EXHIBIT A

Reviewed for Code Compliance

CASA AZUL RESTAURANT & PLAZA

DIMENSIONAL PLAN

1 DIMENSIONAL PLAN
C-3.0 1" = 20'

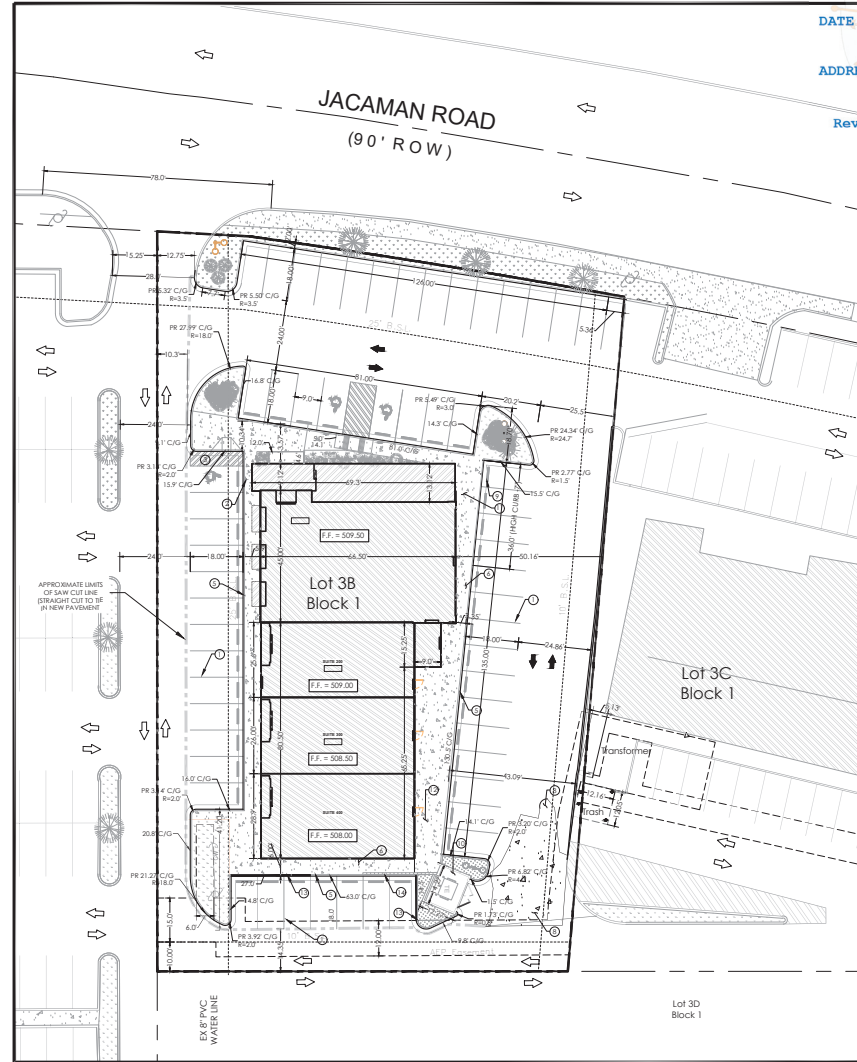
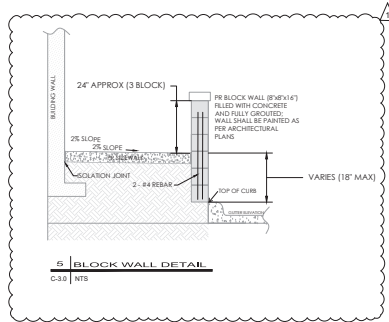
CROSSWALK STRIPPING

When crosswalk lines are used, they shall consist of solid white lines that mark the crosswalk. They shall be not less than 150 mm (6 in) nor greater than 600 mm (24 in) in width.

Guidance: If transverse lines are used to mark a crosswalk, the gap between the lines should not be less than 1.8 m [6 ft]. If diagonal or longitudinal lines are used without transverse lines to mark a crosswalk, the crosswalk should be not less than 1.8 m [6 ft] wide. Crosswalk lines, if used on both sides of the crosswalk, should extend across the full width of pavement or to the edge of the intersecting crosswalk to discourage diagonal walking between crosswalks. For added visibility, the area of the crosswalk may be marked with white diagonal lines at a 45-degree angle to the line of the crosswalk or with white longitudinal lines parallel to traffic flow.

When diagonal or longitudinal lines are used to mark a crosswalk, the transverse crosswalk lines may be omitted. This type of marking may be used at locations where substantial numbers of pedestrians cross without any other traffic control device, at locations where physical conditions are such that added visibility of the crosswalk is desired, or at places where a pedestrian crosswalk might not be expected.

Guidance:
If used, the diagonal or longitudinal lines should be 300 to 600 mm (12 to 24 in) wide and spaced 300 to 1500 mm (12 to 60 in) apart. The marking design should avoid the wheel paths, and the spacing should not exceed 2.5 times the line width.
